Access Compliance Report Public Rights-of-Way (Curb Ramps)

Main Street: CLUB VIEW DR **Cross Street: KELLOGG DR** Location: SW ADA ID: RPAT210922104517 Ramp Type: Type 4 - Parallel **Initial Pass/Fail: Pass Overall Compliance: No Severity Score:**

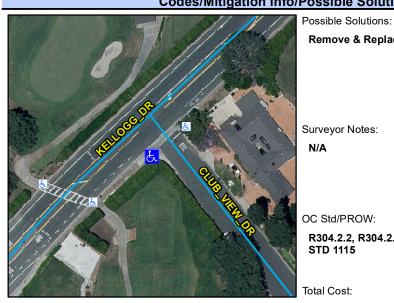
Codes/Mitigation Info/Possible Solution

Remove & Replace Entire Ramp.

R304.2.2, R304.2.1, R304.2.2-Perp, R304.3.2-Para,
